♦ ♦ ♦ ♦ **ADDENDUM TO BID** ♦ ♦ ♦ ♦

PRE-ENGINEERED METAL BUILDING

Bid Title: PRE-ENGINEERED METAL BUILDING
Bid No.: 15-5300.PRE-ENGINEERED METAL BUILDING
Addendum No.: 1
Issued: November 21, 2014

ADDENDUM TO: Pre-Engineered Metal Building
Bid No. 15-5300.PRE-ENGINEERED METAL BUILDING (Lube Center)
2:00 p.m., December 2, 2014

ISOMETRIC VIEWS

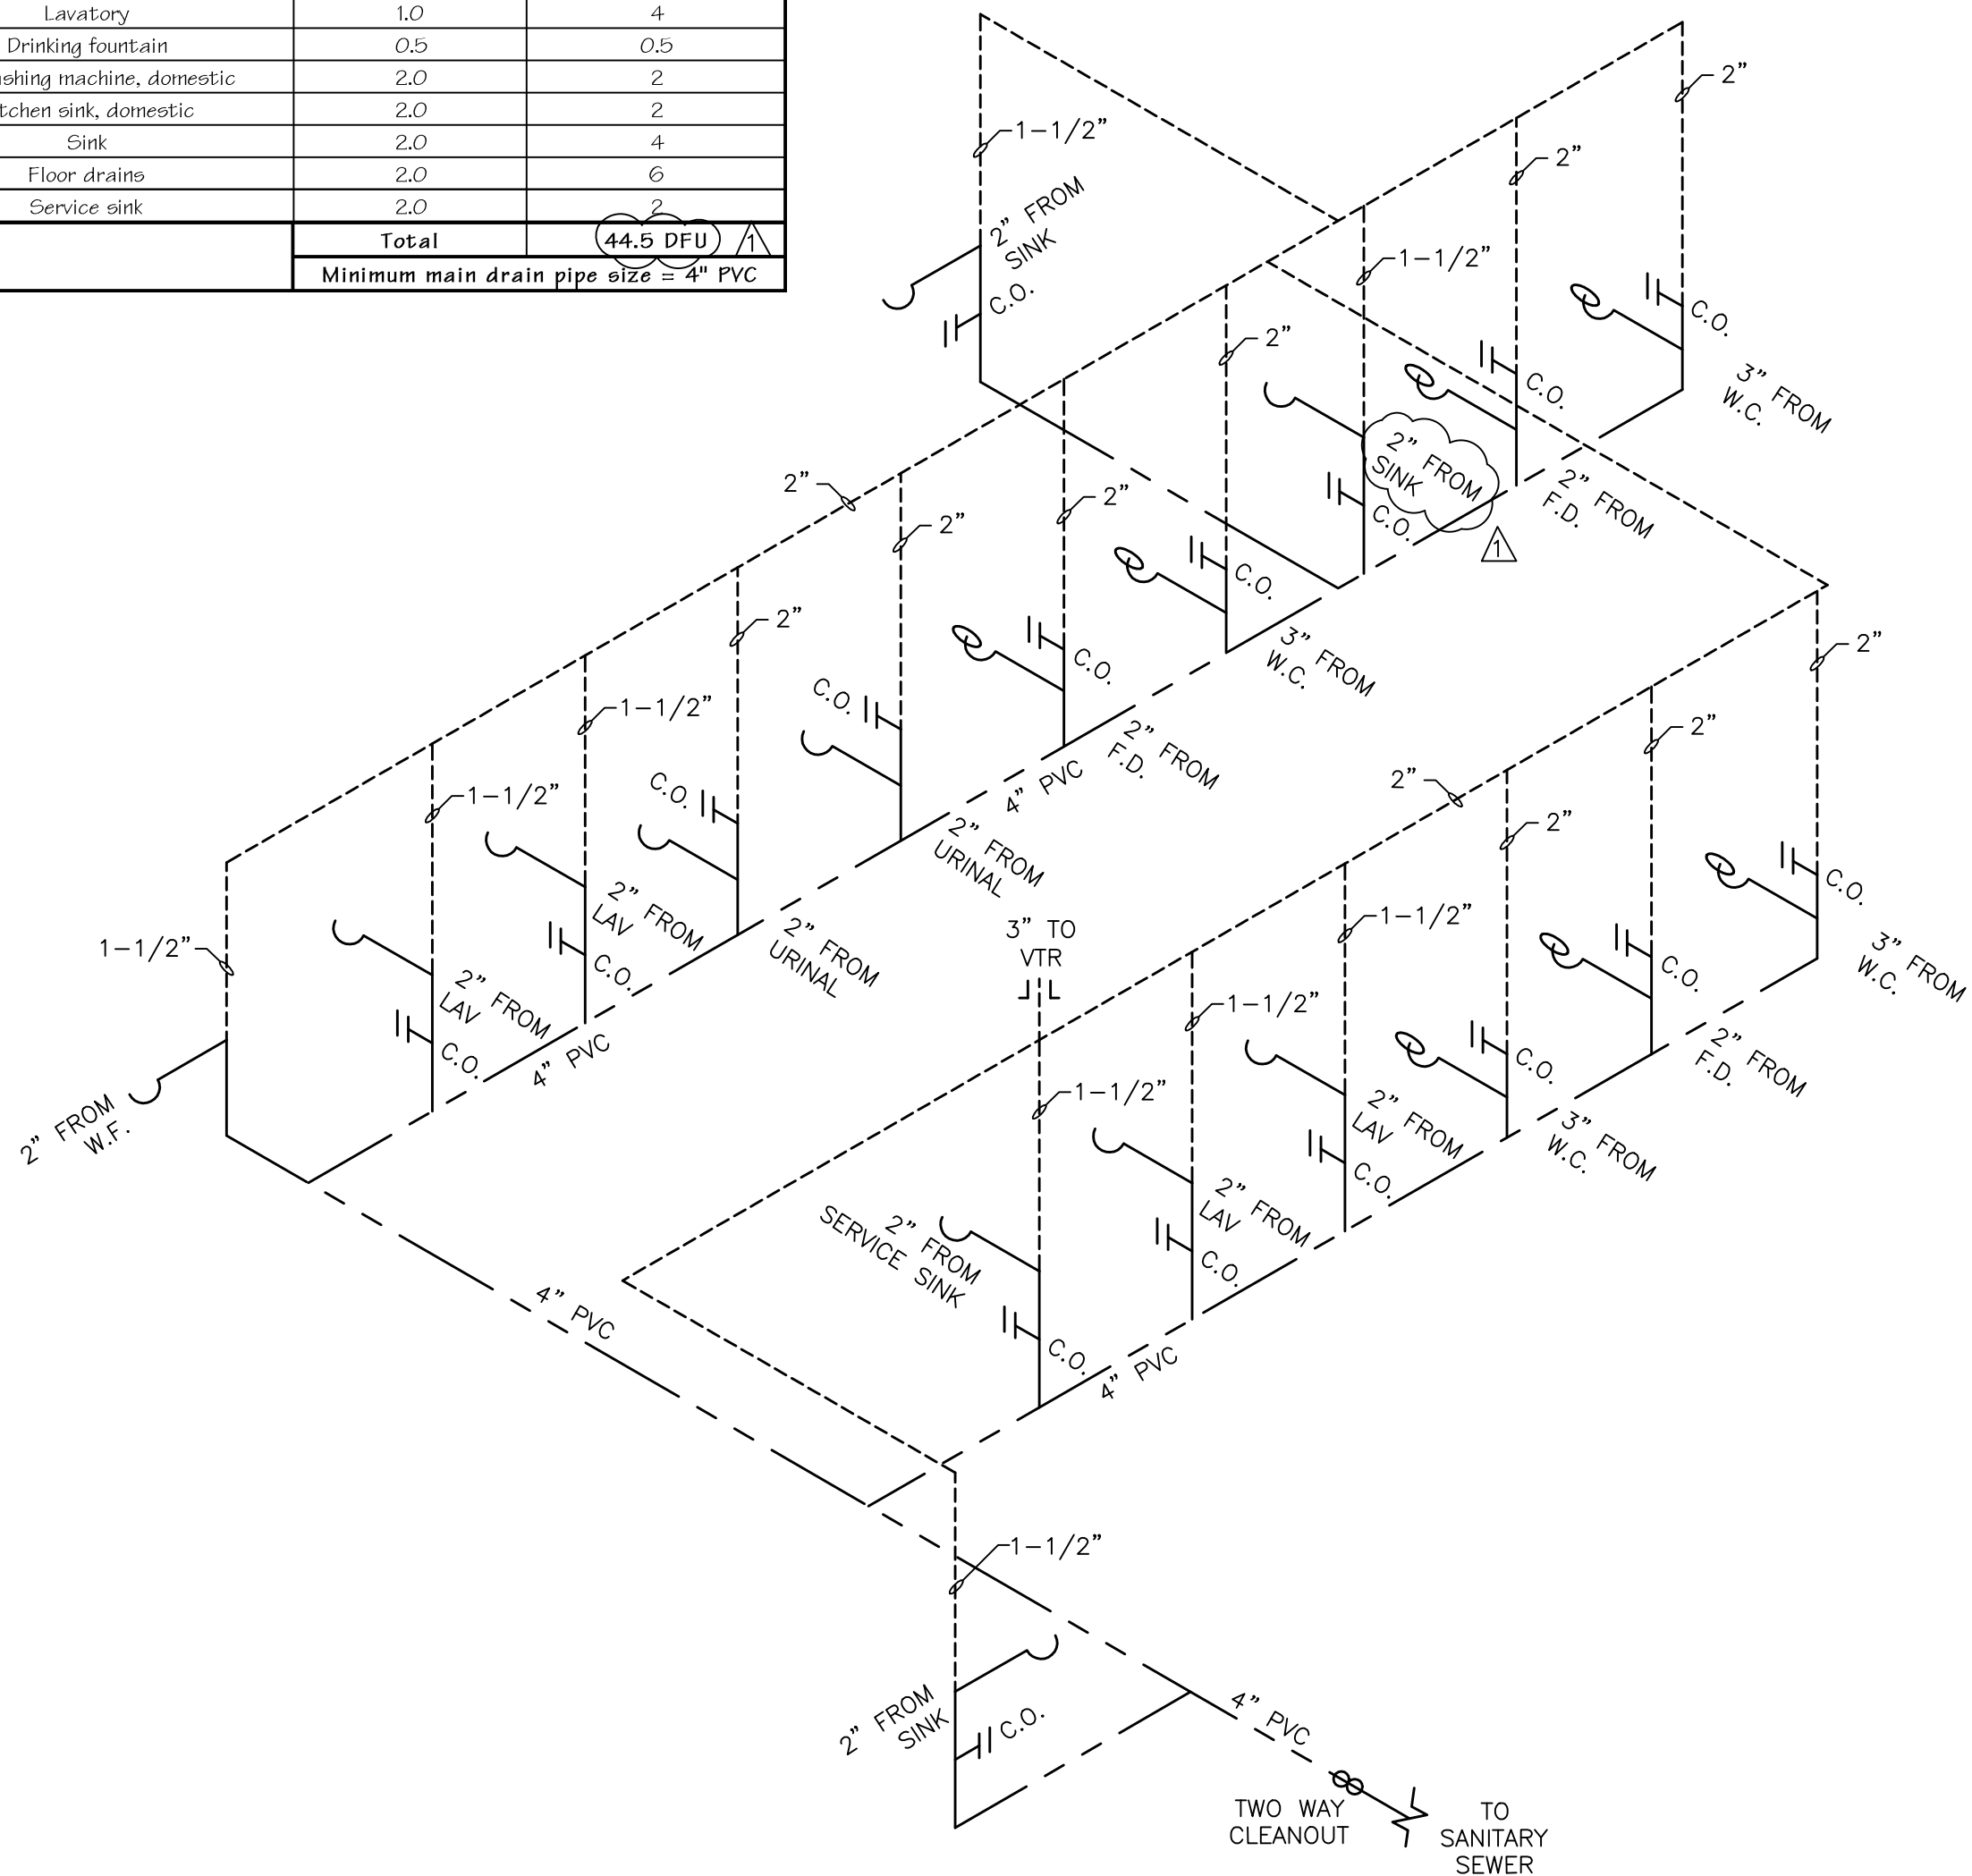
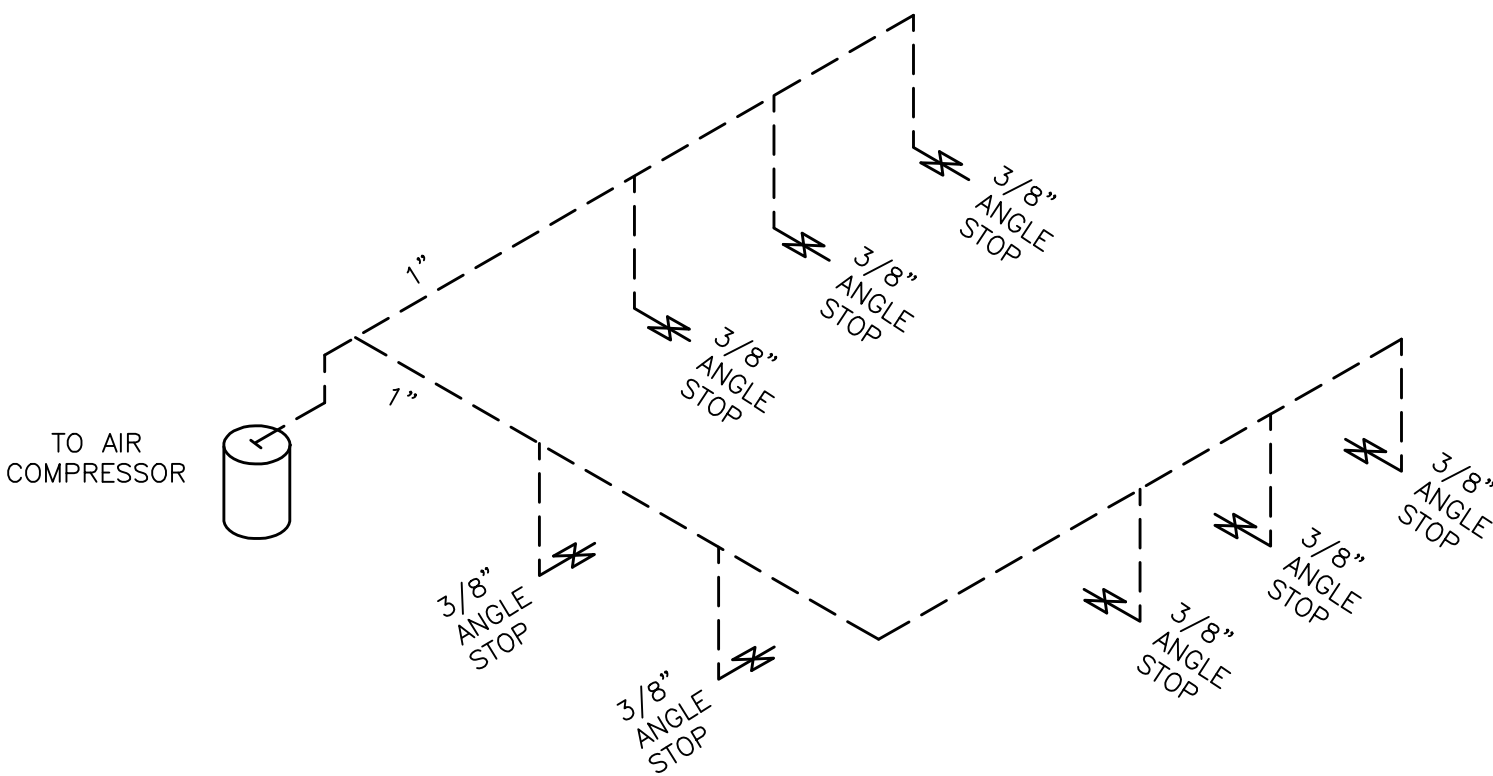
UPDATED PROPOSED NATURAL GAS DEMAND TABLE. UPDATED SIZES ON GAS PIPING. UPDATED LAV TO SINK IN RESTROOM. UPDATED QUANTITIES IN FIXTURE UNIT COUNT TABLES.

Response: Yes. Gas piping was originally sized for supply pressure of 2psi. To avoid regulators, we re-sized the piping for 4oz supply pressure. Please see attached drawings.

A8.1

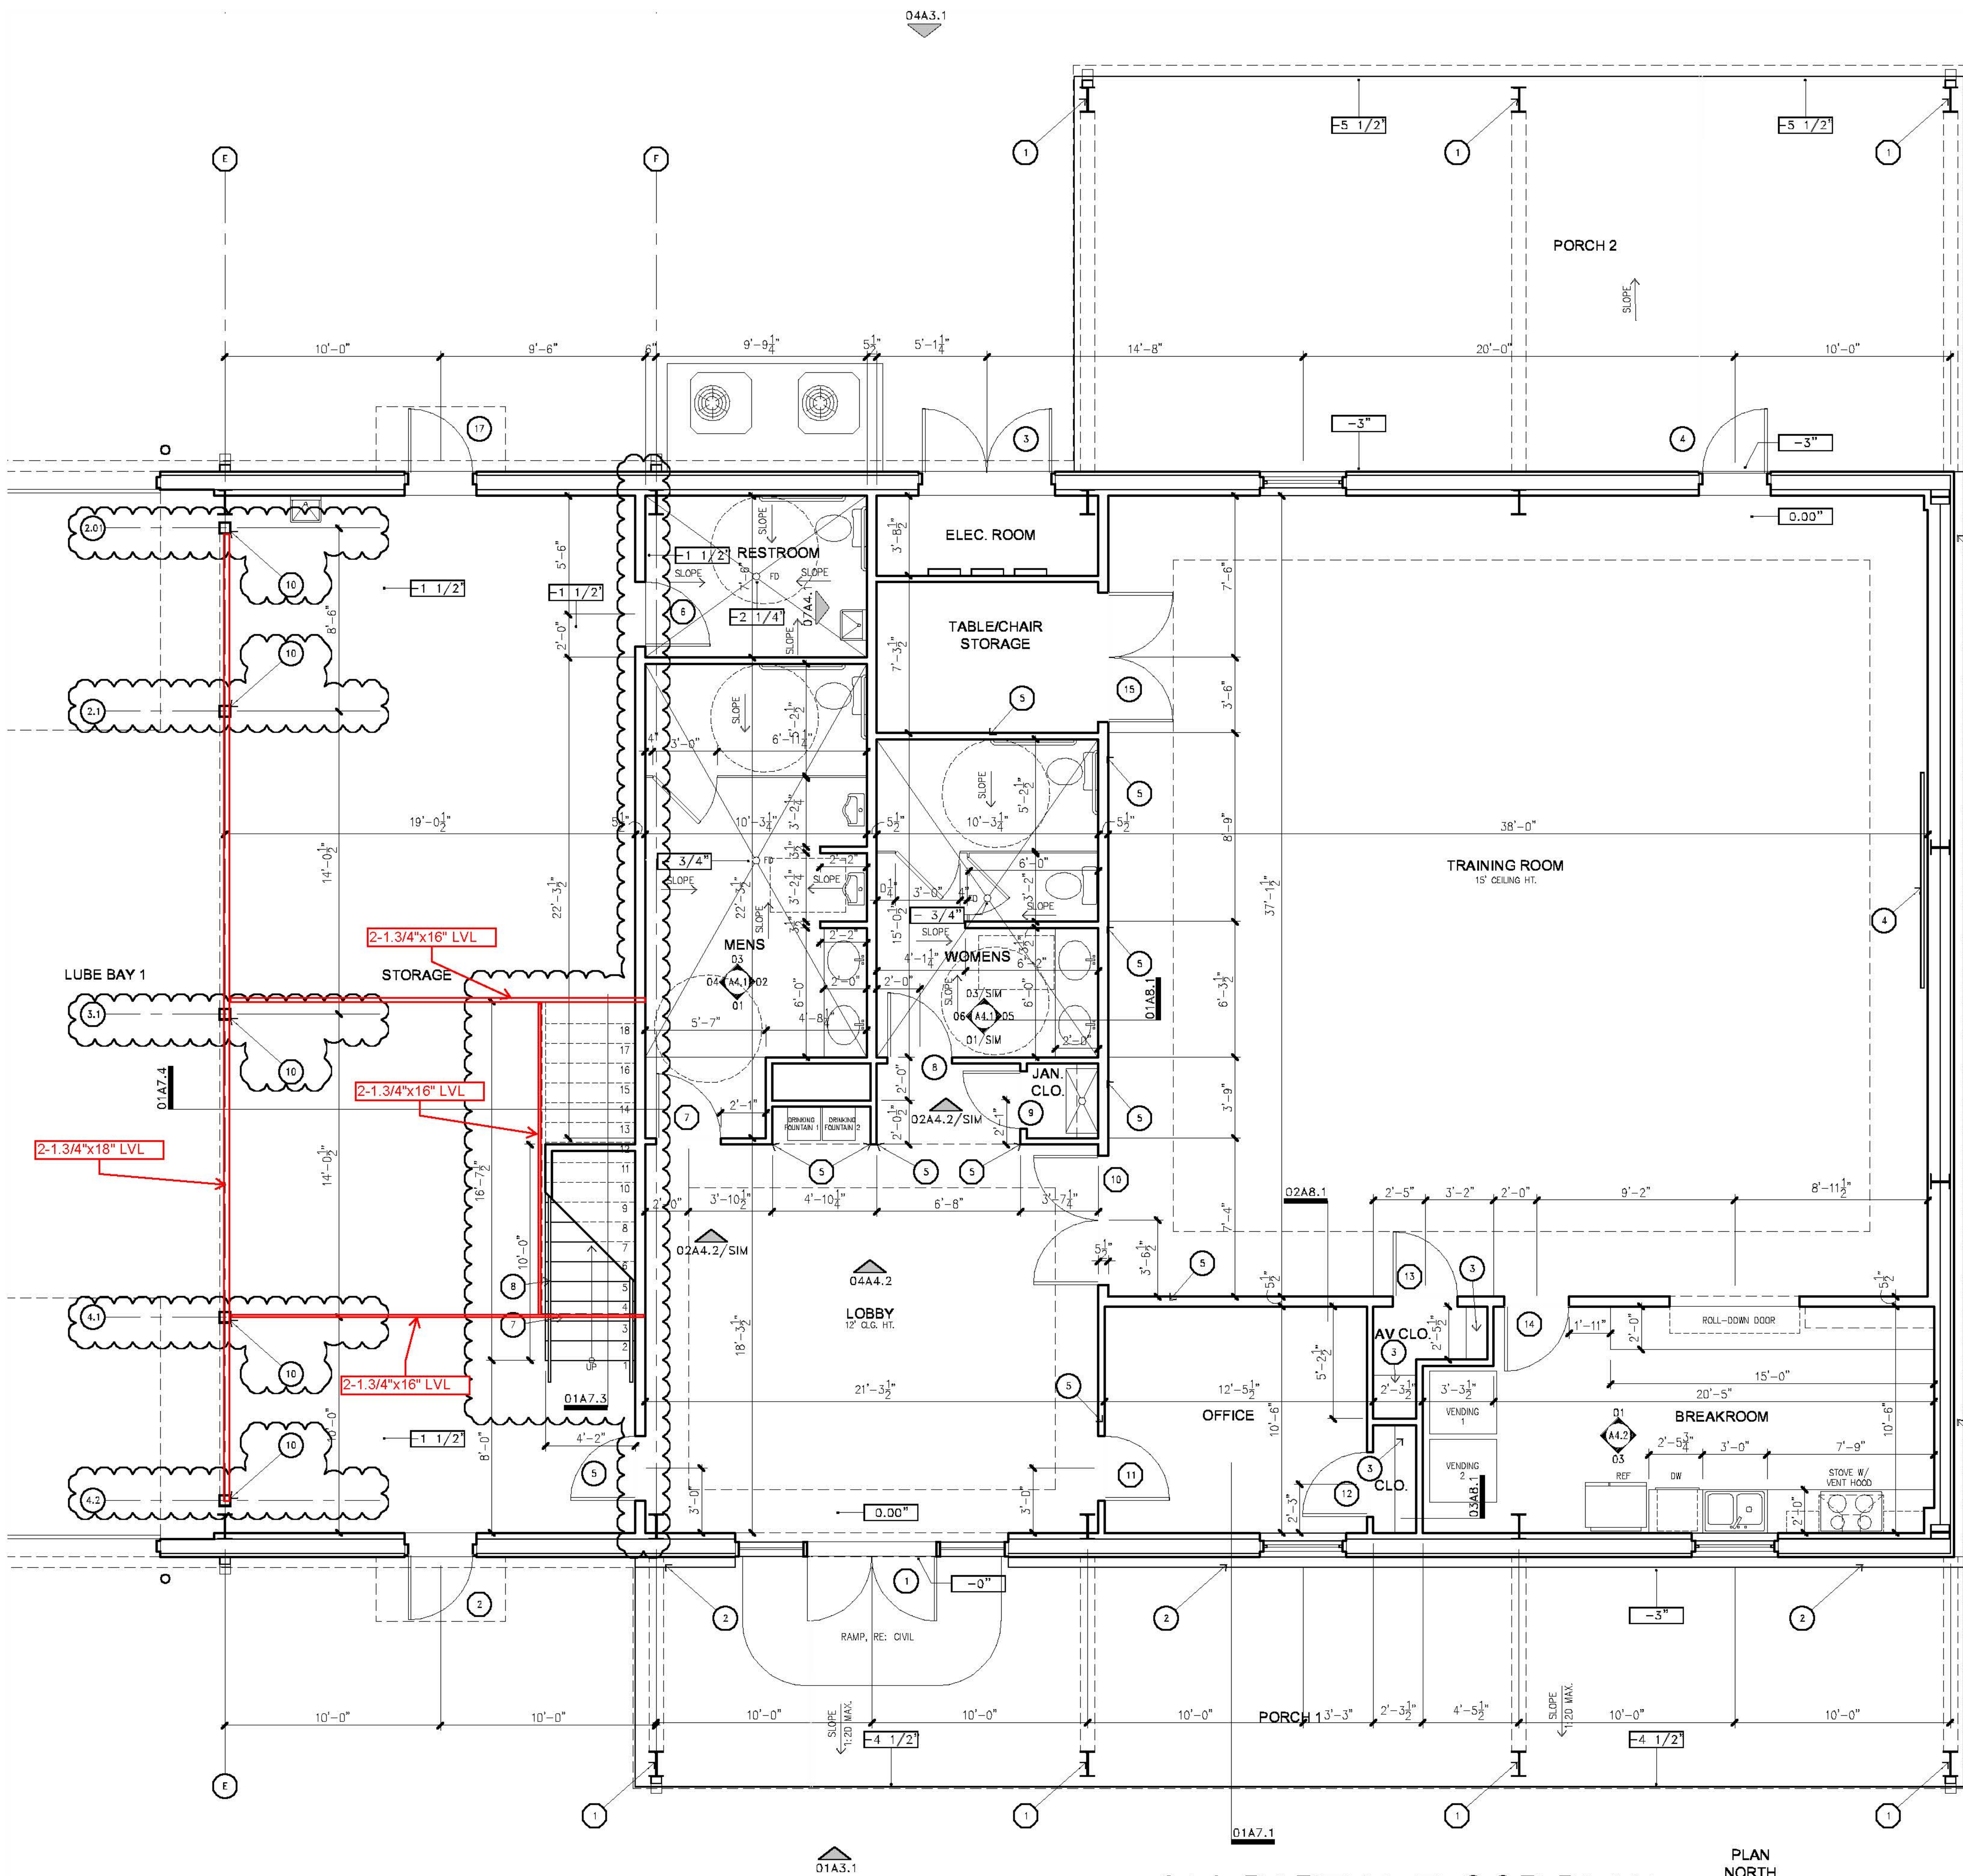
38. *Question:* 1/A8.1 shows the insulation extending 4' past the wall in the break room, the adjacent ceiling is not in the same plane, please clarify.

Response: See updated sheet A8.1.
